MODIF EXPORT SUPERSTAR 3900 EFT

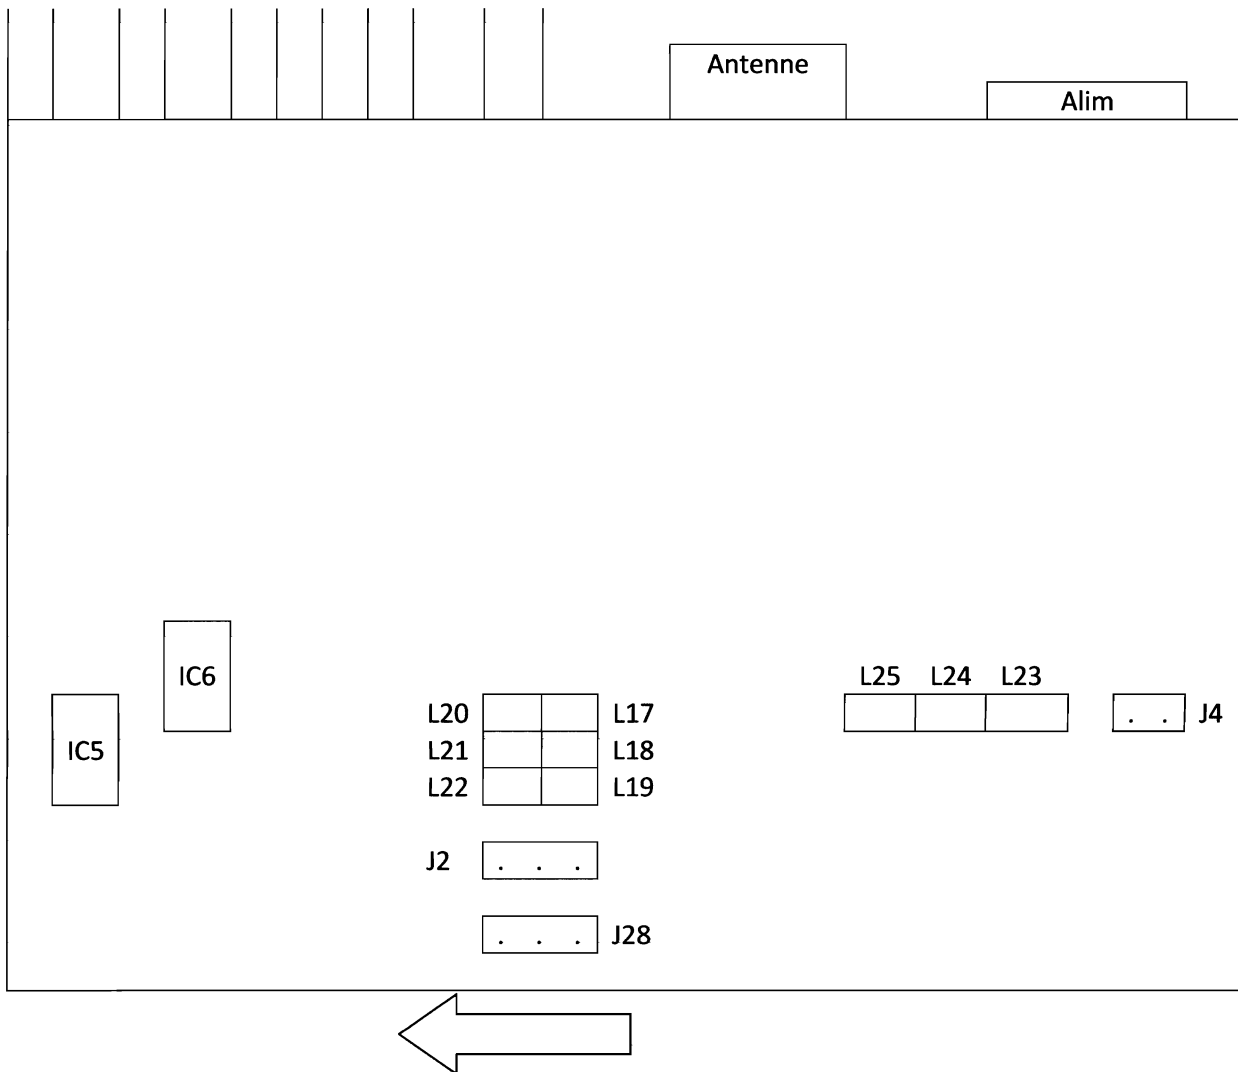
MOVE THE STRAP **J28** OF A NOTCH IN THE SENSE OF THE ARROW

MOVE THE CONNECTOR **J4** ON THE CONNECTOR **J2**

DELETE THE WELDED RESISTANCE ON **IC5** (weld side)
